Cobb County Community Development Agency
Zoning Division

Case # Z-26

FINAL ZONING STAFF RECOMMENDATION:

Austell Seniors

01 Architectural Site Plan

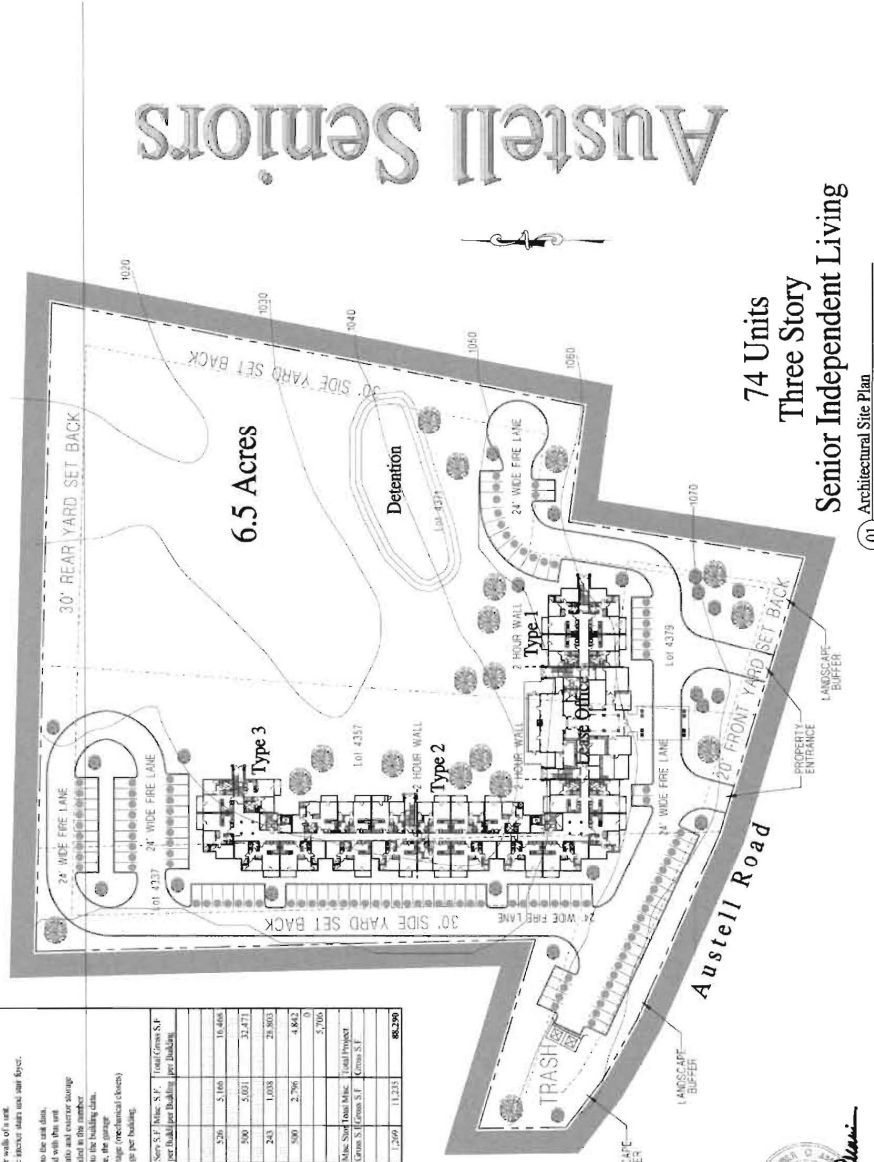
1. Waive the required 50-foot landscape buffer abutting residentially zoned properties;
2. Waive the required 10-foot landscape buffer abutting non-residential properties;
3. Allow more than four units attached side by side;
4. Waive the maximum building height from two stories to three stories; and
5. Waive the maximum density from five units per acre to 11.38 units per acre.

The proposed configuration of the parking areas does not appear to satisfy the Cobb County Tree Ordinance. Additional parking lot peninsulas, as determined during the site plan review process, may be required.

- The proposed detention pond location will require significant grading. It may be possible to relocate the pond to a more natural location centrally in the site depending on field verification of stream buffer limit.

1. Maximum of five units per acre;
2. Maximum of 35 feet in height;
3. No variances;
4. Water and Sewer Division comments and recommendations;
5. Stormwater Management Division comments and recommendations; and
6. Department of Transportation comments and recommendations.
